ATTACHMENT B

PROPOSED CHANGE TO APPENDIX A

TECHNICAL SPECIFICATION TO OPERATING LICENSE

NPF-11

Figure 3.4.1.1-1

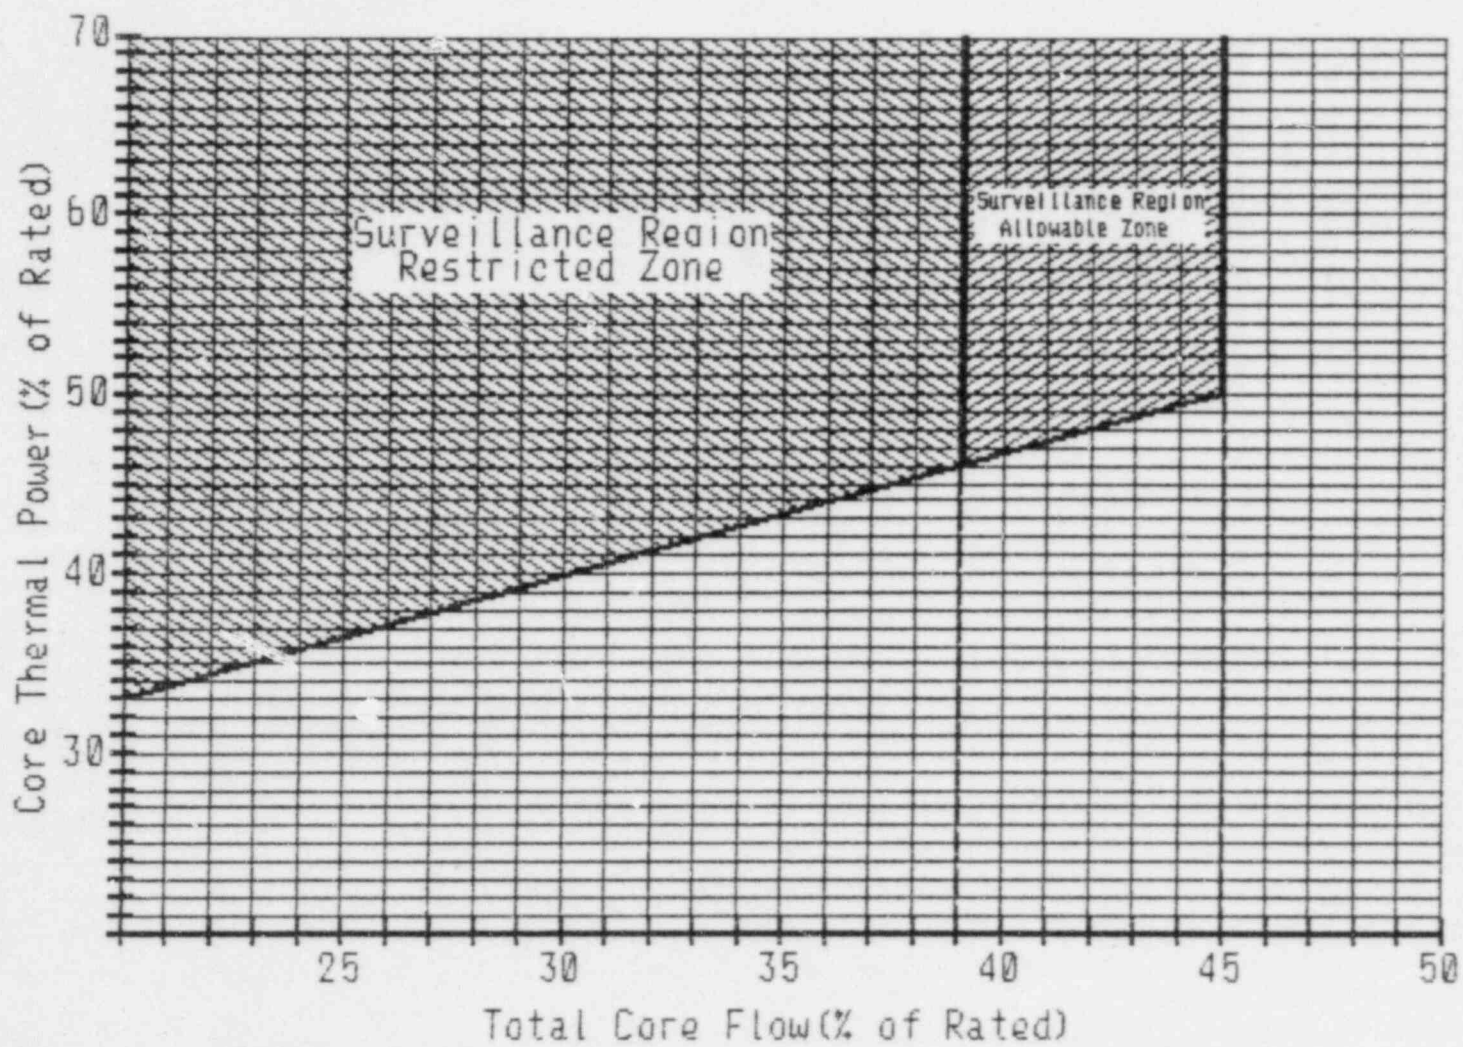
To ensure stability, single loop operation is limited in a designated restricted region (Figure 3.4.1.1-1) of the power-to-flow map. Single loop operation with a designated surveillance region (Figure 3.4.1.1-1) of the power-to-flow map requires monitoring of APRM and LPRM noise levels.

2. When operating within the surveillance region specified in Figure 3.4.1.1-1:
  - a. With core flow less than 39% of rated core flow, initiate action within 15 minutes to either:
    1. Leave the surveillance region within 4 hours, or
    2. Increase core flow to greater than or equal to 39% of rated flow within 4 hours.
  - b. With the APRM and LPRM<sup>#</sup> neutron flux noise level greater than three (3) times their established baseline noise levels:
    1. Initiate corrective action within 15 minutes to restore the noise levels to within the required limit within 2 hours, otherwise
    2. Leave the surveillance region specified in Figure 3.4.1.1-1 within the next 2 hours.

- a. Establish baseline APRM and LPRM<sup>#</sup> neutron flux noise level values within 4 hours upon entering the surveillance region of Figure 3.4.1.1-1 provided that baseline values have not been established since last refueling.
- b. When operating in the surveillance region of Figure 3.4.1.1-1, verify that the APRM and LPRM<sup>#</sup> neutron flux noise levels are less than or equal to three (3) times the baseline values:
  1. At least once per 12 hours, and
  2. Within 1 hour after completion of a THERMAL POWER increase of at least 5% of RATED THERMAL POWER, initiating the surveillance within 15 minutes of completion of the increase.
- c. When operating in the surveillance region of Figure 3.4.1.1-1, verify that core flow is greater than or equal to 39% of rated core flow at least once per 12 hours.
